RE: Response Letter
61 John Vertente Boulevard – New Bedford, MA
SE 049-0791

On behalf of the applicant, Tim Cusson and 61 SMRE, LLC, please find revised Site Plans and documentation enclosed with this letter. Revisions have been made in response to the comment letter prepared by the Nitsch Engineering dated April 30, 2018 in regards to their review of the Site Plans. Our responses to the comments provided in the review letter are provided on the following pages.

Nitsch Comments

LAYOUT & GRADING PLAN
SHEET 3 OF 5

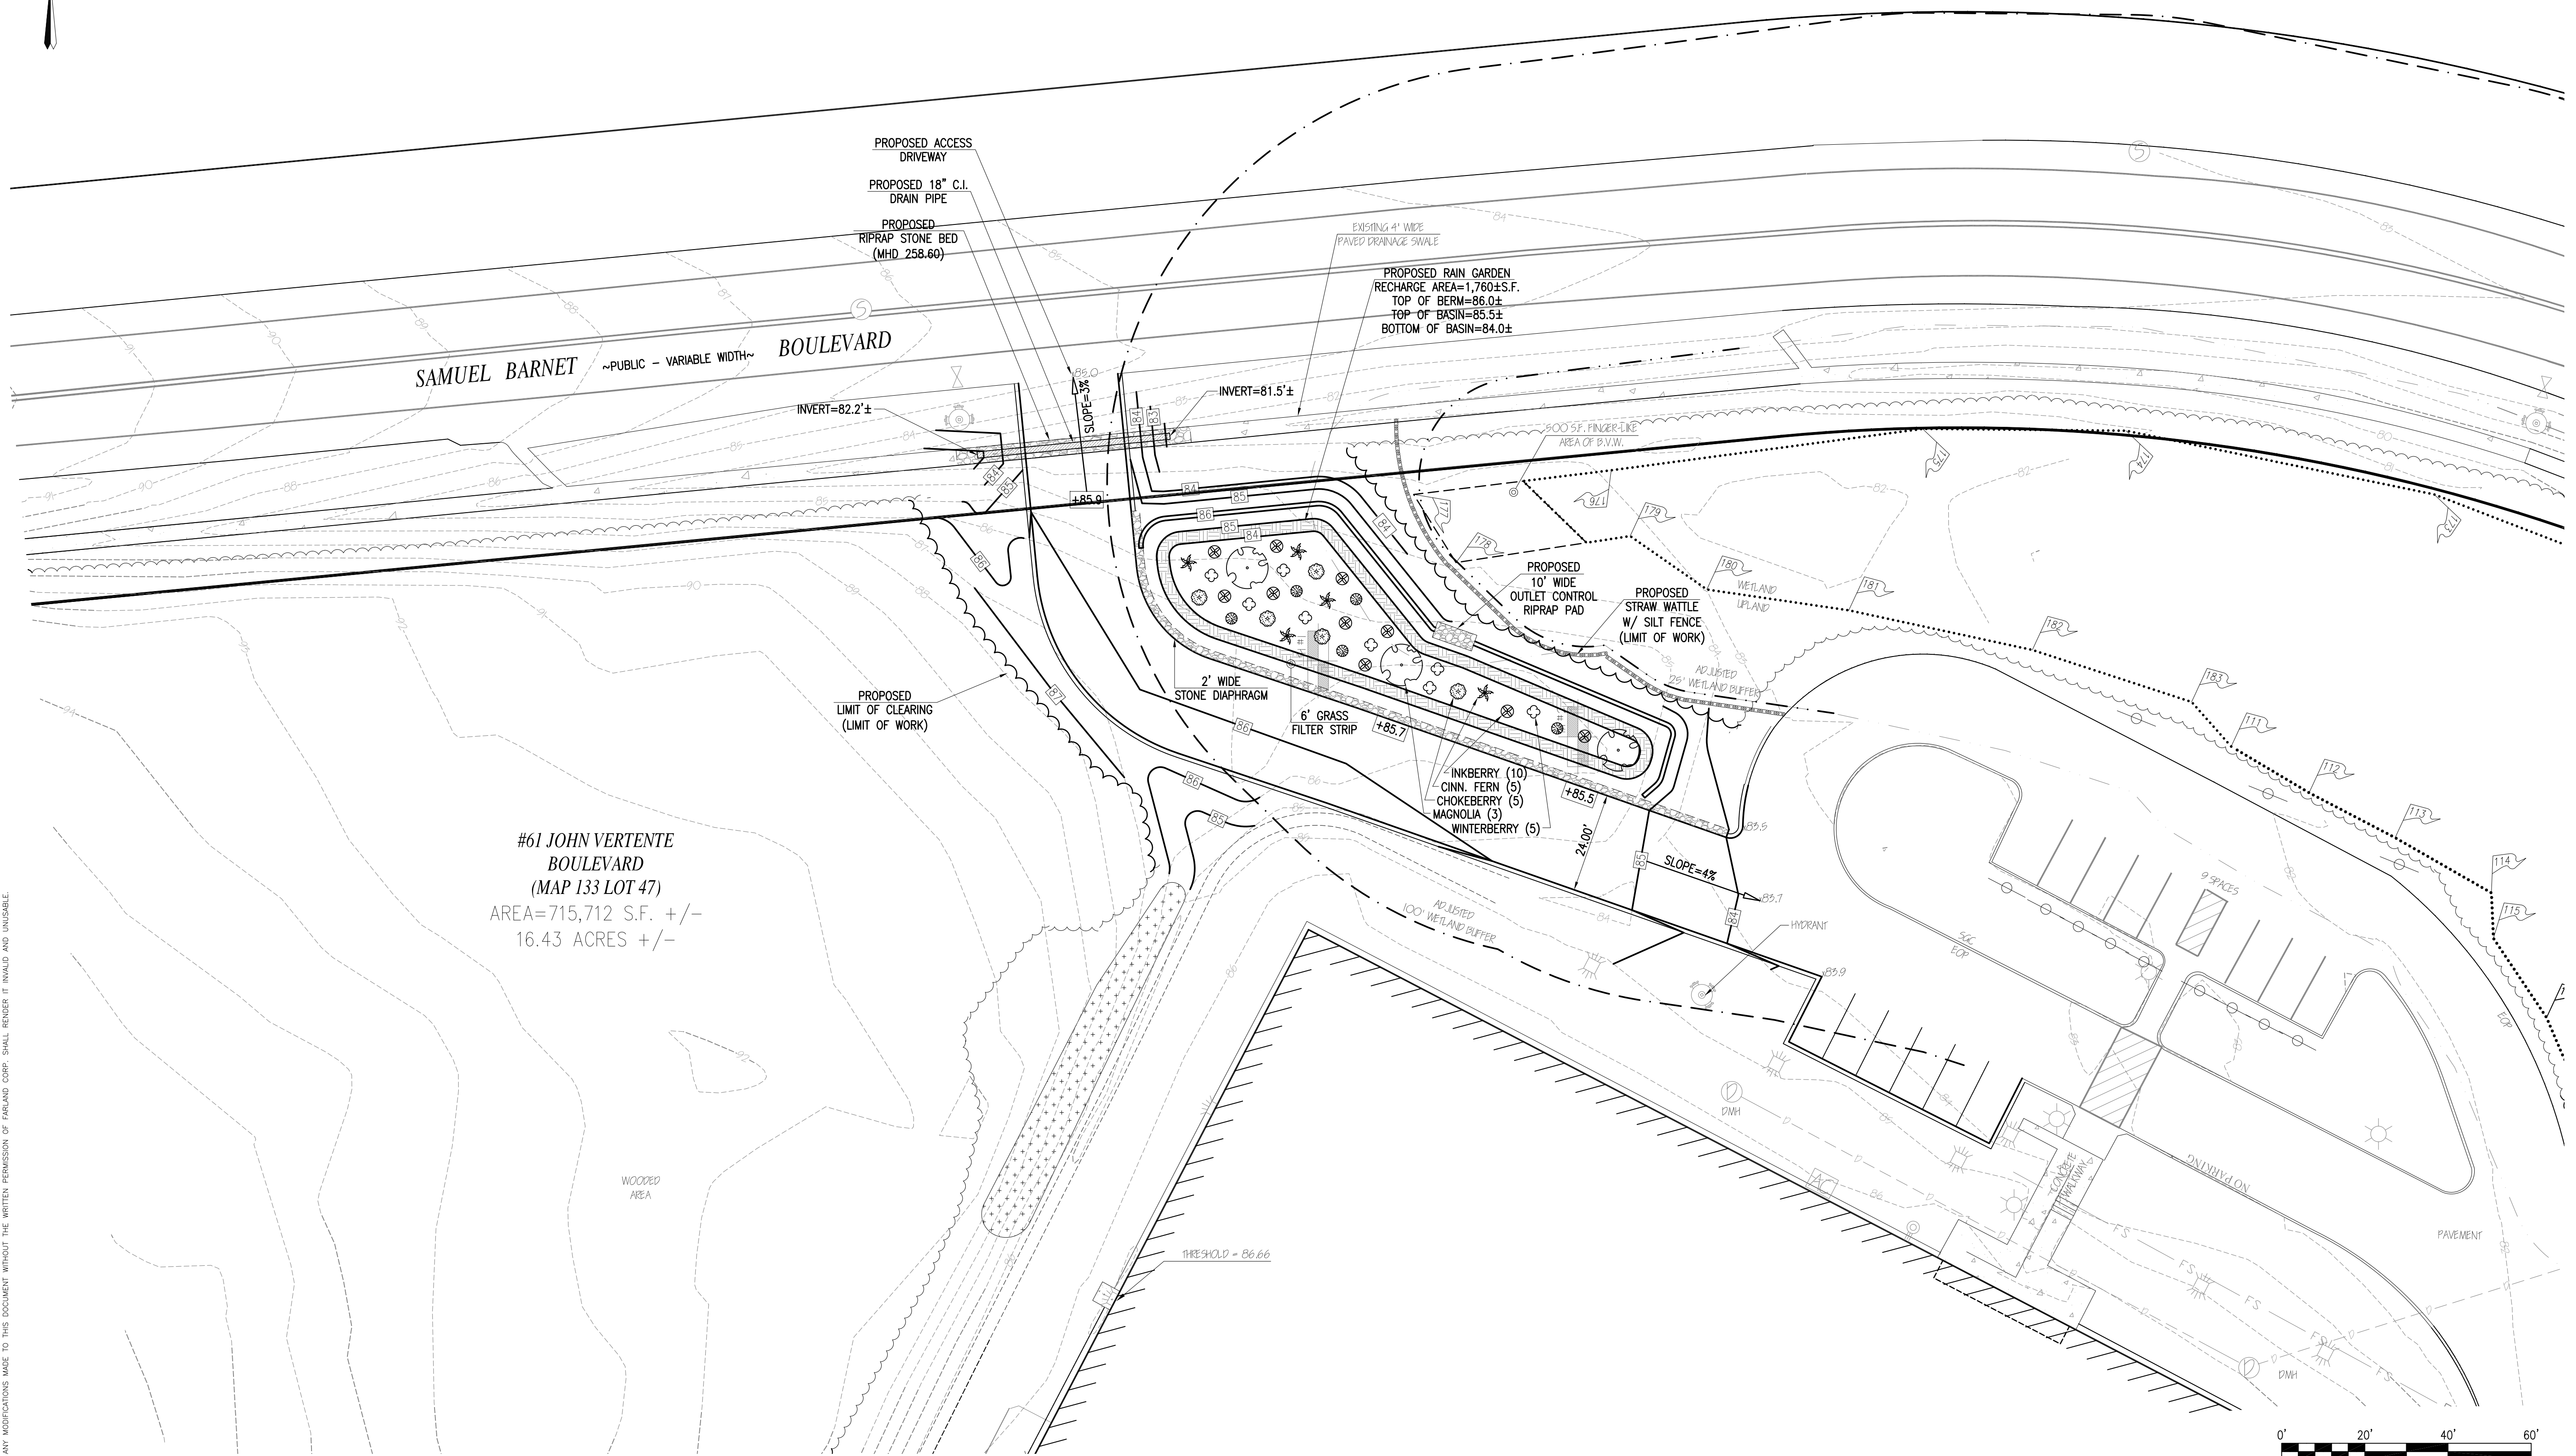
Existing conditions calculations were provided for review. However, these calculations only include the area of disturbance for the proposed project and do not include all of the areas upstream of the project that flow into the driveway and ultimately the rain garden.

Similar to the existing conditions, the proposed conditions do not include the areas upstream (southwest) of the proposed driveway. All areas flowing to the rain garden should be included in the existing and proposed conditions calculations.

We recommend that more detailed grading of the driveway be provided. The driveway appears very steep where it meets the existing pavement.

These areas southwest of the proposed access driveway have been revised to provide grassed swales as shown on the grading plan (Sheet 3). By doing so, the stormwater will be re-routed to where they currently flow and will not add to the required storage of the rain garden.

See Previous Response

Additional spot grades have added to the plan along with proposed slopes at each transition to adequately portray the proposed conditions, as requested.

FLARED END OUTLET

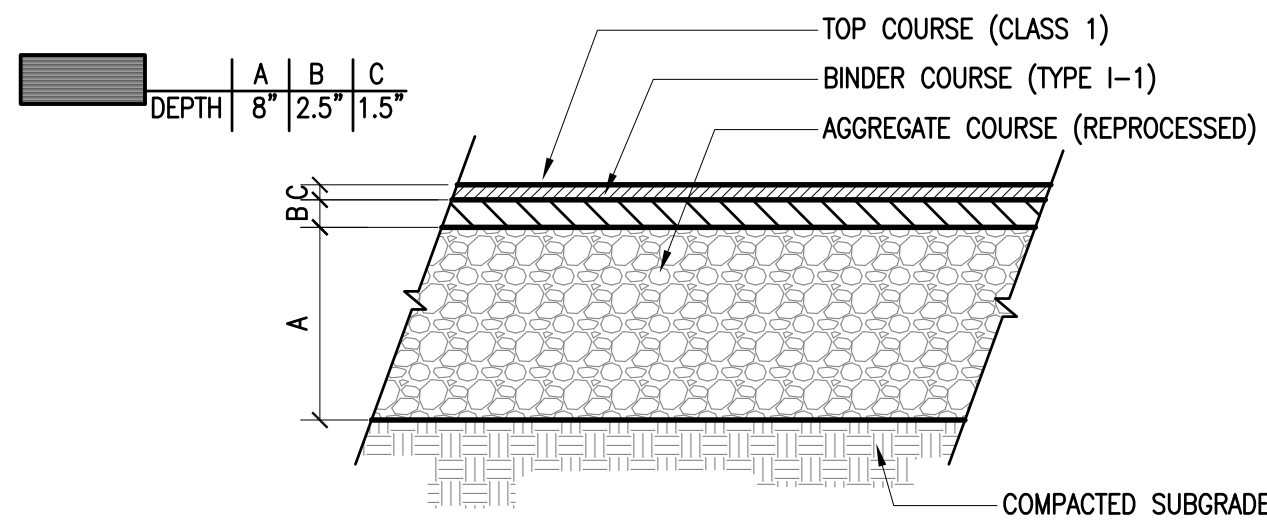
We recommend that the stone shown at the outlet to the culvert be described as stone for pipe ends (MHD 258.60) and that a detail be provided for the end pipe condition.

As requested, a detail for the end of pipe condition has been added and appropriately labeled for the correct Mass Highway specifications.

BROAD-CRESTED STONE OUTLET WEIR

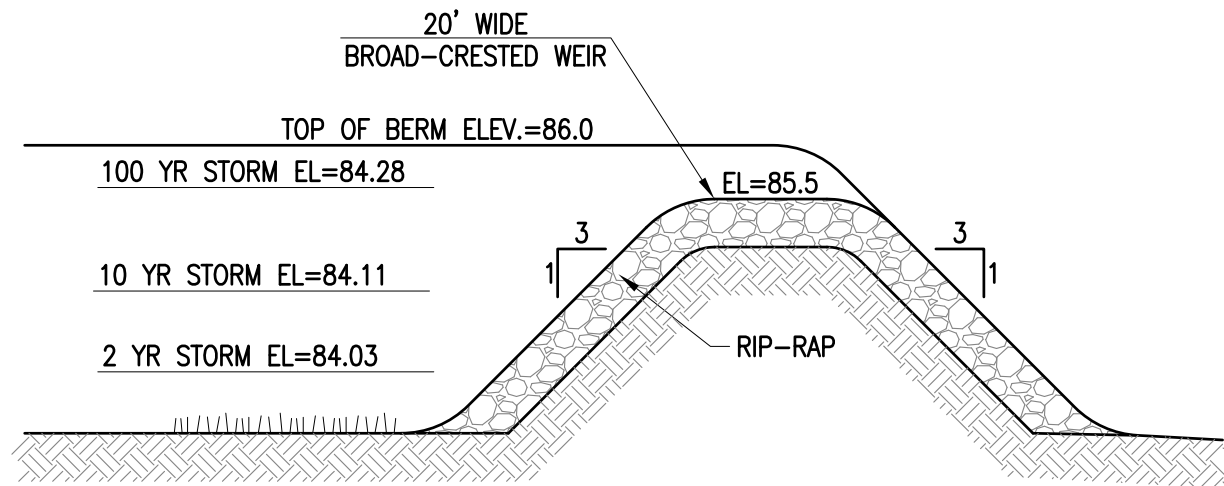
An overflow detail was added to the plans. The elevations on the detail are inconsistent with the site plan.

The elevations on the overflow detail have been revised to be consistent with both the site plan and HydroCAD calculations.
